**Comments on the  
Grants Reclamation Project, Updated Corrective Action Program (CAP)  
Homestake Mining Company of California, March 2012**

George Rice  
October 30, 2012

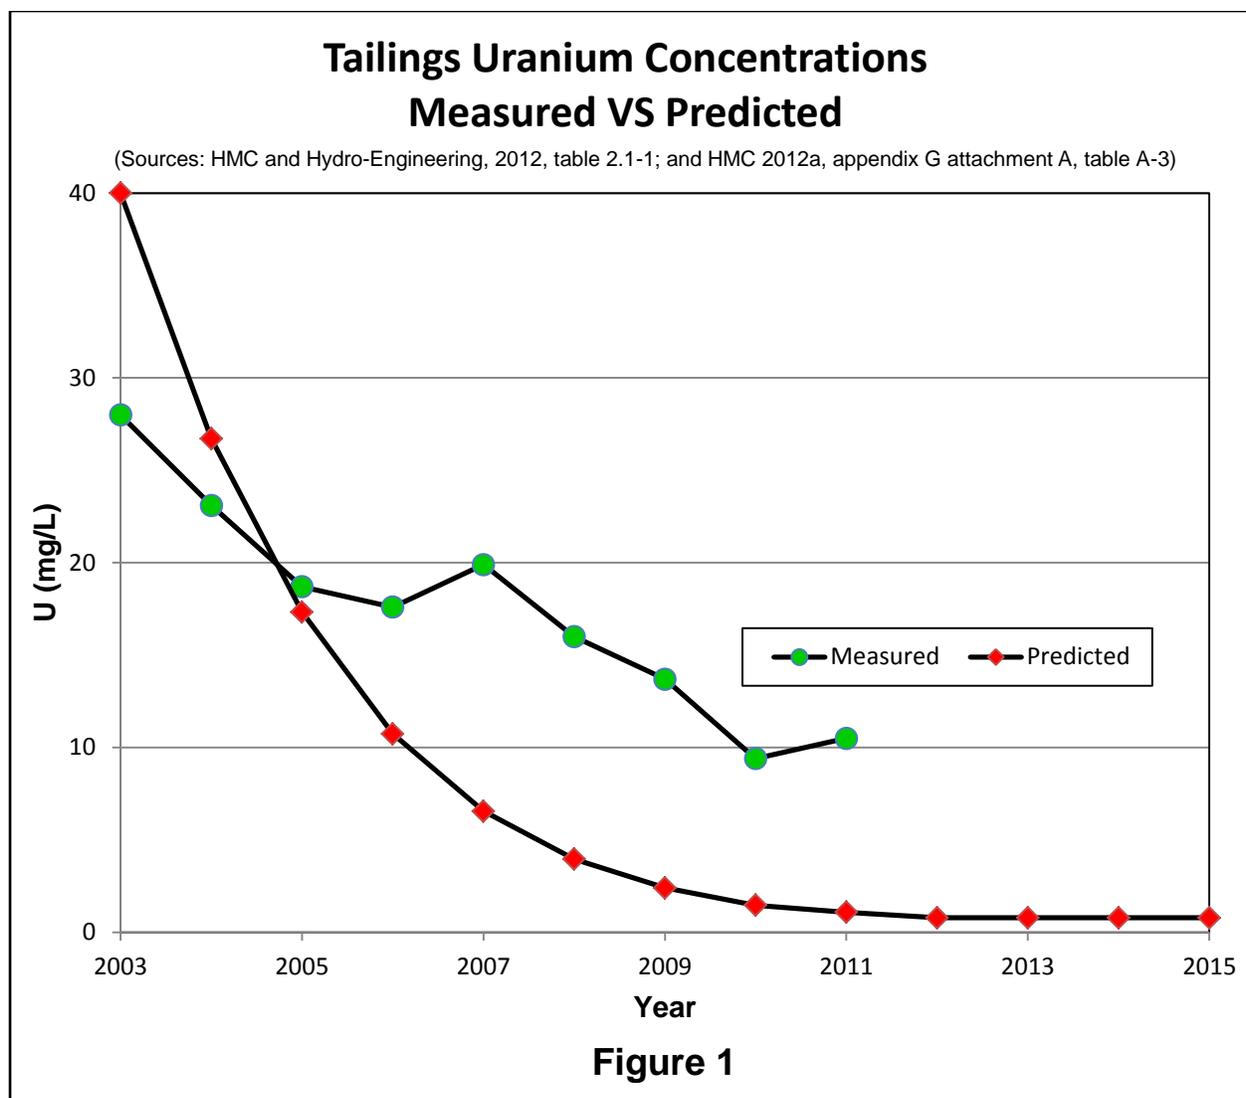
Finally, Homestake's predictions of uranium concentrations in the pile have not matched-up well with measured concentrations. This mismatch is illustrated in figure 1.
